Bommasandra Nayakanahalli tank in Mysore territory: Directing the S.E. II Circle to expedite the ~~afresh~~ submission of the information called for by the Chief Engr. for Irrign. in connection with the proposal to raise the weir level of the — and ordering that the Resident in Mysore be informed that a reply to his letter will be sent on receipt of ~~the~~ ~~that~~ that information.

Bommasandra Nayaka-
-nalu Tank — Note relative
to the proposal of Mysore
Durbar to raise the weir
level of the —

Bommasamudra Nayakaralu tank. Note relative to the proposal of Mysore Durbar to raise the weir level of —

Extract from Topo sheet No. 40
Shewing the position of Bommasandra Nayakarallakere

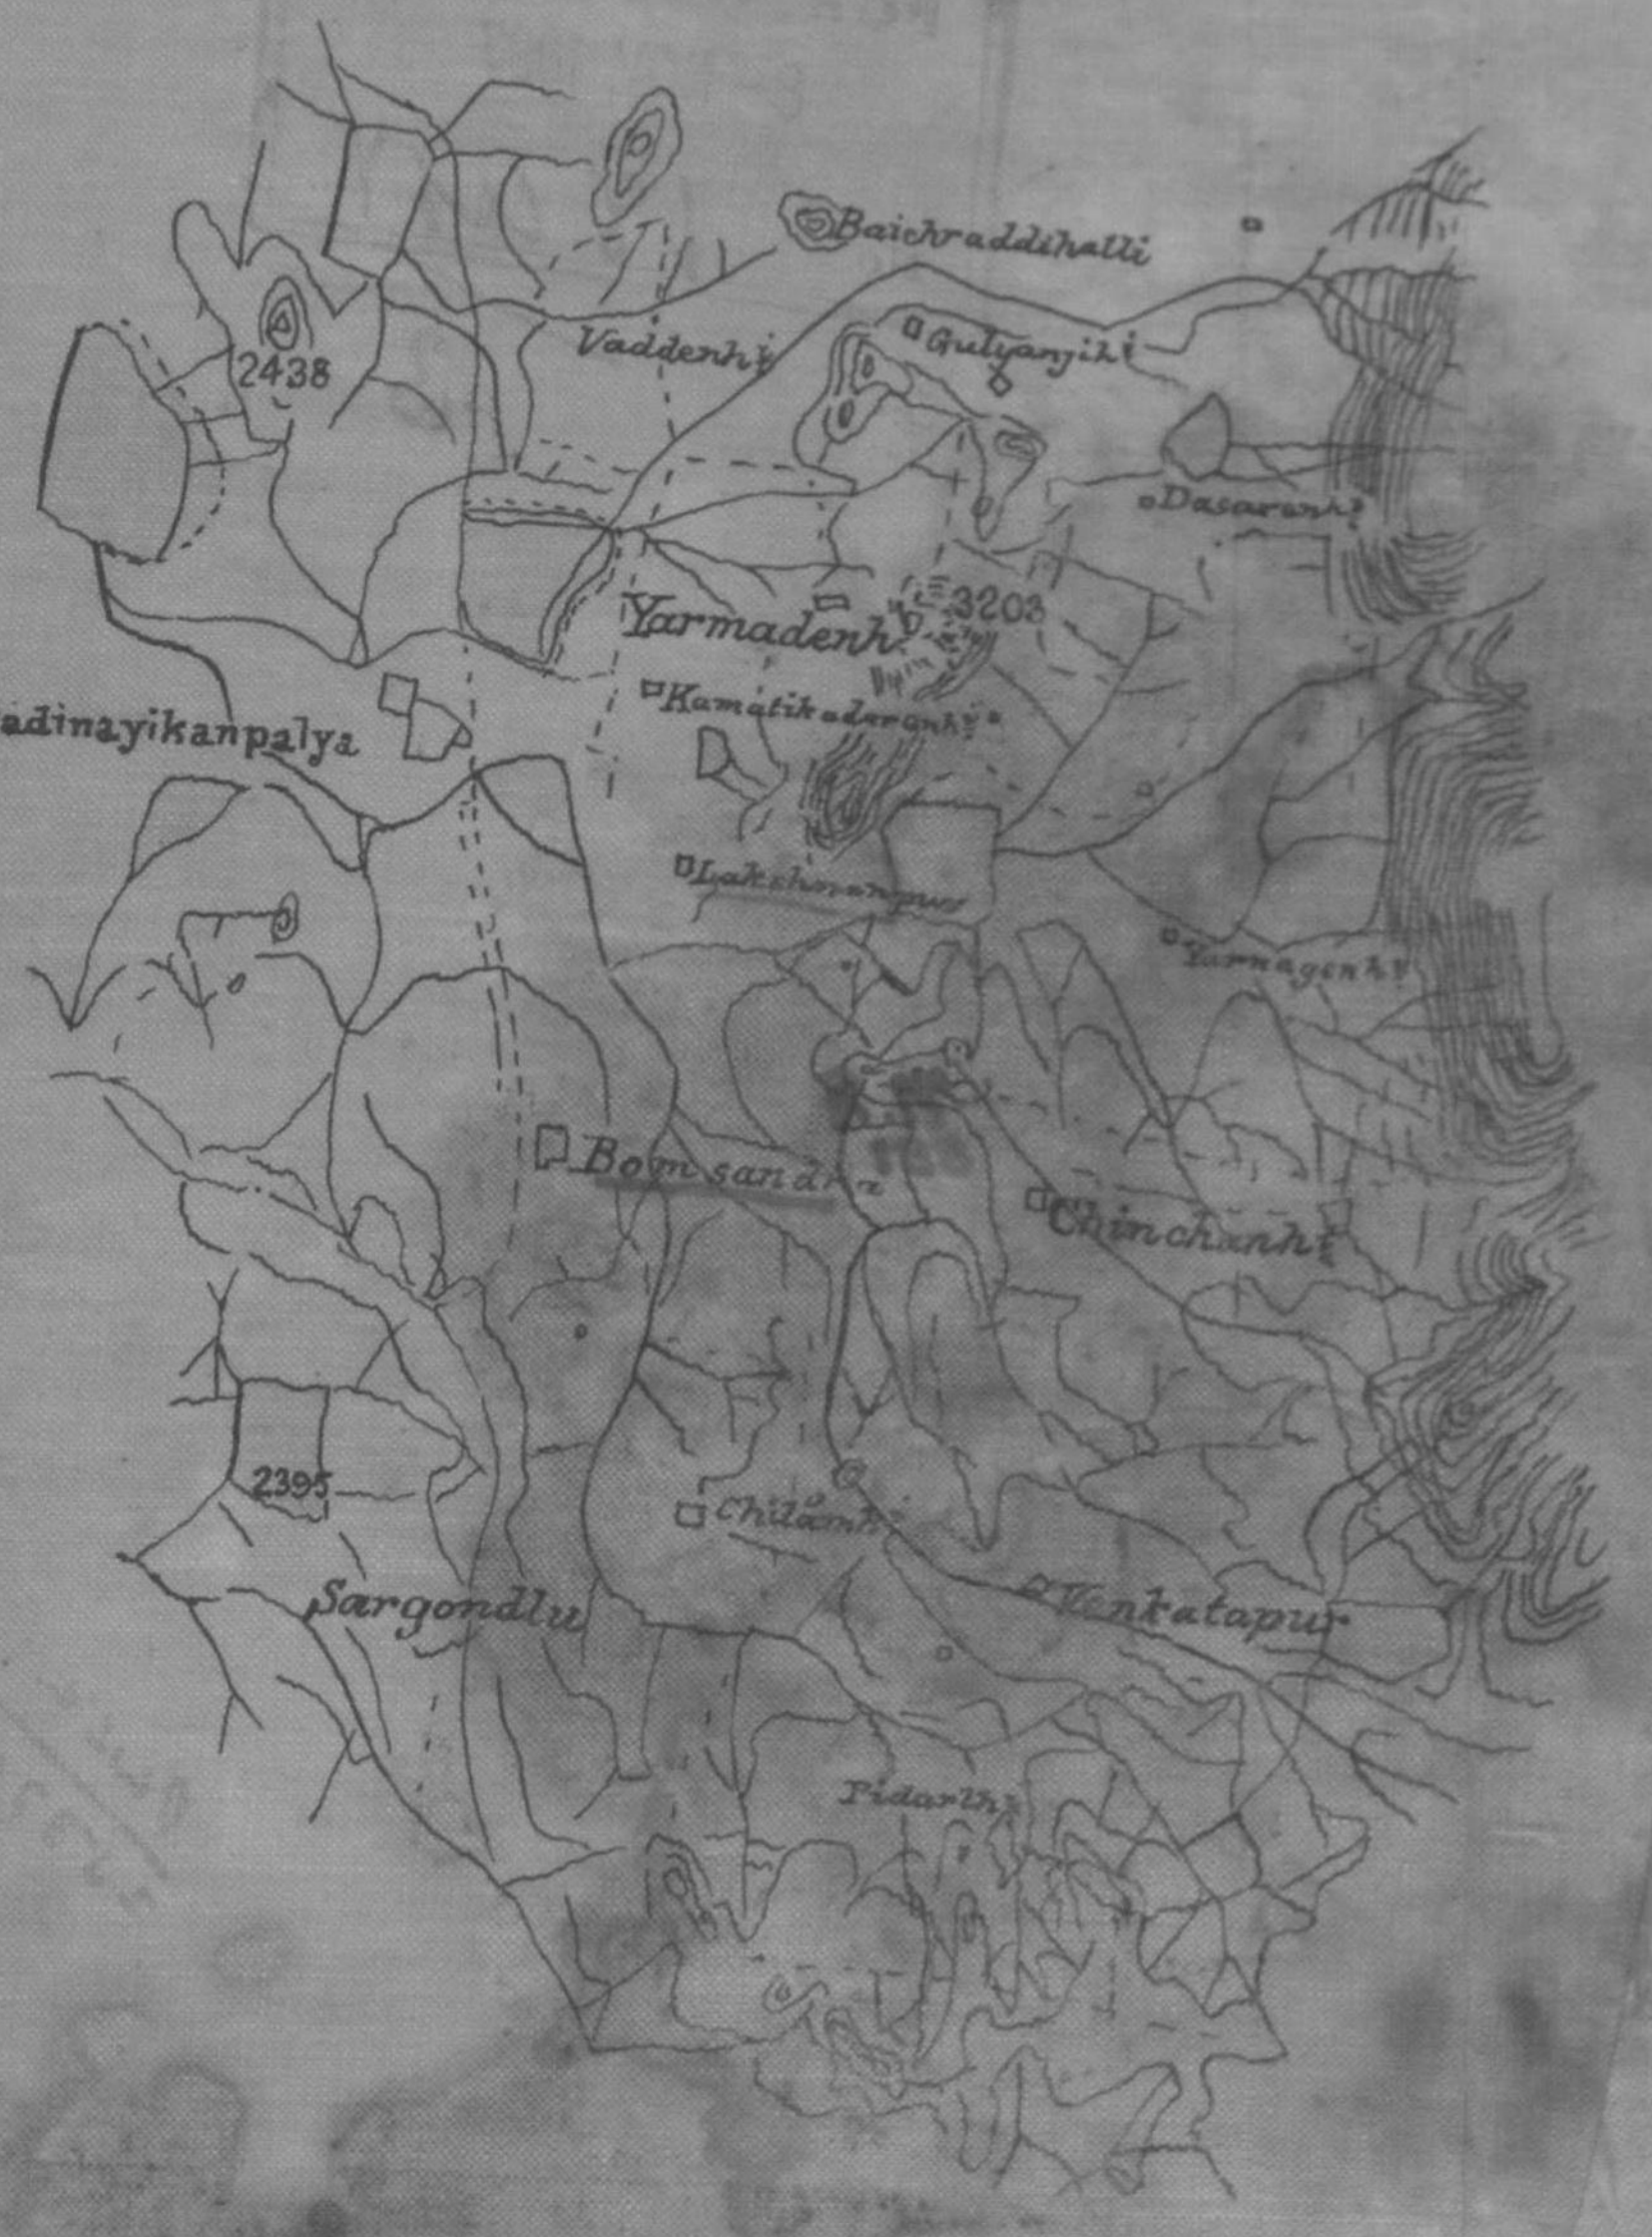
I have the honor to request that you will be so good as to move the Resident to obtain the consent of the Government of Madras to the remodel of the Bommansandra Nayakaralu Tank, Registered No 188, in Gowribidnur Taluk, Kolar District, (which is within the prescribed area, vide enclosed tracing) being raised by 4 feet, which will increase the Capacity of the Tank from 30 to 82 units. If the Madras Government will not agree to this, will they agree to the weir being raised by at least 2 feet which will increase Capacity to 53 units? A large extent of irrigable lands depends on this tank than can be properly irrigated by its present Small Capacity.

EXTRACT FROM GROUP MAP

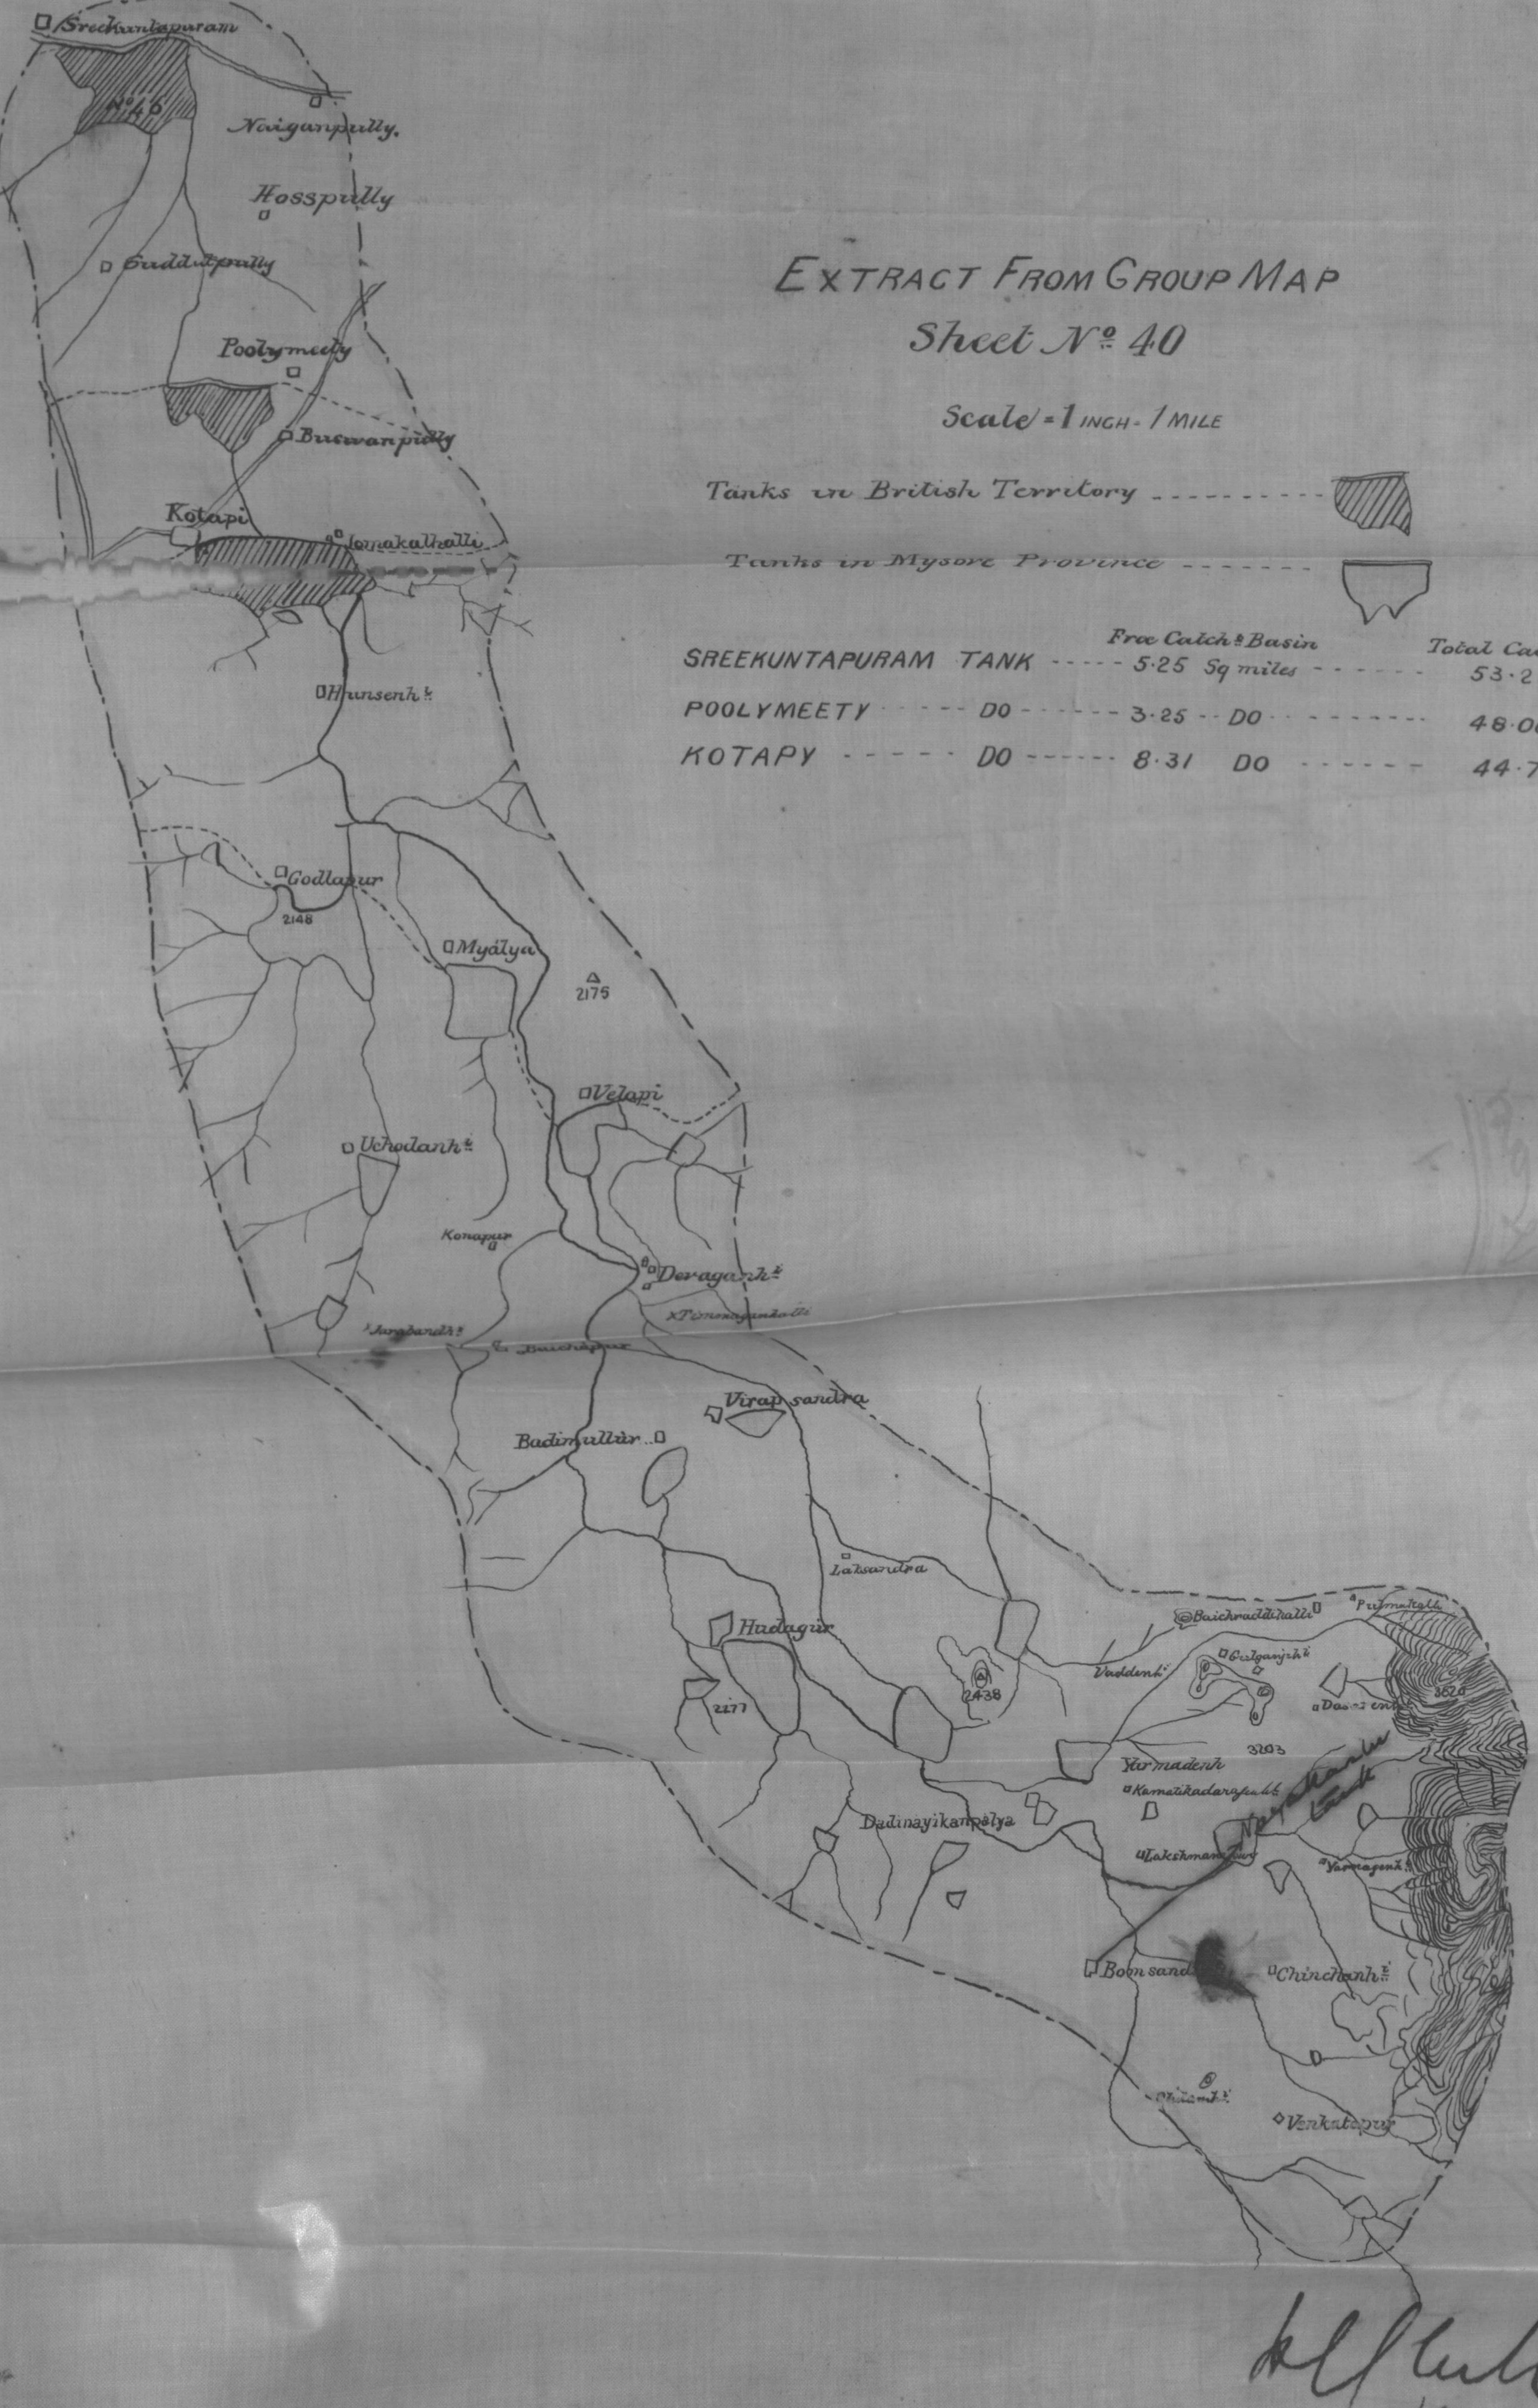
With reference to your No. 2088 dated 8-7-97 forewarding the Mysore Residents letter Camp No. 39 dated 11-6-97 regarding the raising of the weir level of the Bommasamudram Nayakarlu Tank, I have the honour to enclose the accompanying tracing and to report as follows.

2. The tank above referred to is situated in the Srikantapuram Tank group, which has a combined catchment area of 53.25 Sqr. miles. The three tanks in the group, which lie within British territory, are as follows:-

3. The rainfall over this area is light and the irrigating power per square mile of catchment is not likely to exceed 30 acres per sqr. mile of catchment. The total irrigating power of the group is therefore only 1600 acres.

probable that the other tanks have an ayacut of over 1500 acres. It is evident therefore that the area under cultivation in the catchment is already in excess of what may be expected to be irrigated in ordinary years, and this is borne out by the fact that the three British tanks above alluded to never get a good supply in years of ordinary rainfall. I therefore strongly advise that no increase of storage should be allowed to any tank within this group.

5. It may be argued that the catchment of the Bommasamudram tank is but small and forms an insignificant portion of the whole area but this argument should not be accepted as it might equally well be applied to each tank in turn with the result that the terminal tanks would get nothing but the run off from their free catchment.

2. Under the circumstances explained by the Divisional Officer it would not be advisable to comply with the request of the Mysore Government.
